Second Revision No. 10-NFPA 291-2020 [Section No. 1.1]

Second Revision No. 2-NFPA 291-2020 [Section No. 1.2]

Second Revision No. 12-NFPA 291-2020 [Section No. 2.4]

Figure 4.4.4 Suggested Test Layout for Hydrants.

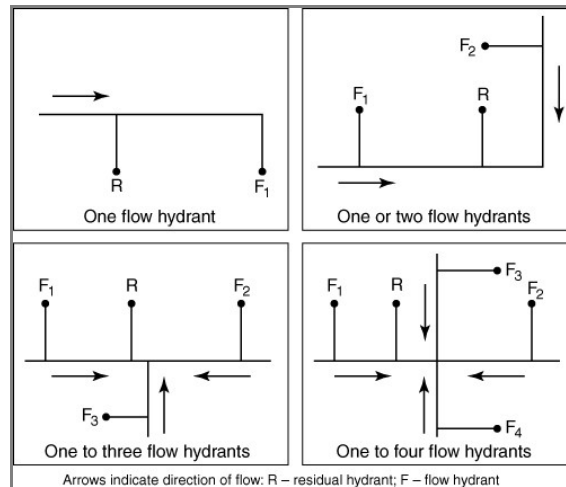
This hydrant is chosen so it will be located between the hydrant to be flowed and the large mains that constitute the immediate sources of water supply in the area. In Figure 4.4.4, test layouts are indicated showing the residual hydrant designated with the letter R and hydrants to be flowed with the letter F.

Committee Statement: The existing recommended practice is best suited for determining the available water supply in the water main, but not necessarily for determining the water flow at an individual fire hydrant. Adding this new section will provide a single hydrant test option for the best practice to determine the water flow of that hydrant with more accuracy.
